Access Compliance Report

Public Rights-of-Way

Intersection ID: 43309	Main Street: ALLENWOOD_RD	Cross Street: FALLS_LAKE_DR	Location: S
ADA ID: C22A881BB588	Ramp Type: PerpDiag	Initial Pass/Fail: Fail	Overall Compliance: No
		Severity Score: 10

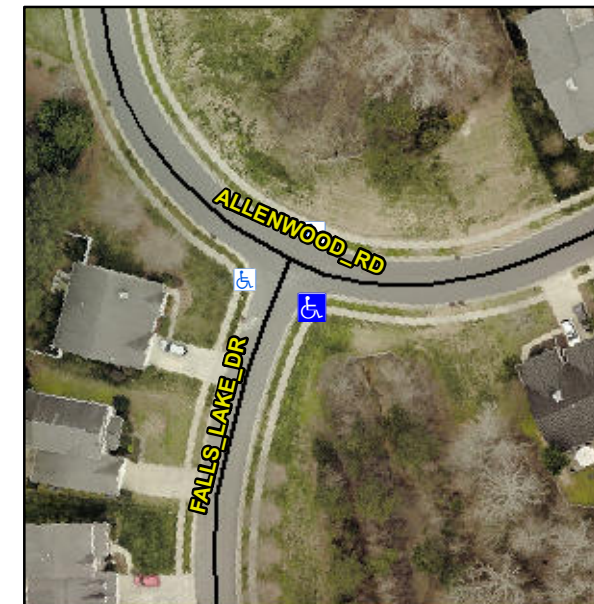
Not Found, R304.5.1, R304.5.3

Compliance	Description	Data	Compliance	Description	Data
N/A	Ramp Length (in)	48.0	Yes	Ramp Slope (%)	6.6
No	Ramp Width (in)	38.0	No	Ramp XSlope (%)	3.1
N/A	Flare Type LT	N/A	N/A	Flare Type RT	N/A
N/A	Flare Slope LT (%)	N/A	N/A	Flare Slope RT (%)	N/A
N/A	Flare Traversable LT?	N/A	N/A	Flare Traversable RT?	N/A
N/A	Landing Length (in)	N/A	N/A	DWS Provided?	N/A
N/A	Landing Width (in)	N/A	N/A	DWS Contrast?	N/A
N/A	Landing Slope (%)	N/A	N/A	DWS Length (in)	N/A
N/A	Landing X Slope (%)	N/A	N/A	DWS Full Width?	N/A
N/A	Landing Curb? (Y/N)	N/A	N/A	DWS Offset (in)	N/A
N/A	Shared Landing?	N/A			
N/A	Gutter Ponding?	N/A	N/A	Gutter Slope (%)	N/A
N/A	Gutter Lip Ht (in)	N/A	N/A	Gutter X Slope (%)	N/A
N/A	Painted X Walk1?	No	N/A	Painted X Walk2?	No
	X Walk 1 Direction	To N		X Walk 2 Direction	To NW
N/A	X Walk 1 Width (in)	N/A	N/A	X Walk 2 Width (in)	N/A
	X Walk 1 Slope (%)	2.3		X Walk 2 Slope (%)	1.9
	X Walk 1 X Slope (%)	2.8		X Walk 2 X Slope (%)	0.2

Remove & Replace Curb Ramp With Two New Directional Ramps or Equivalent.
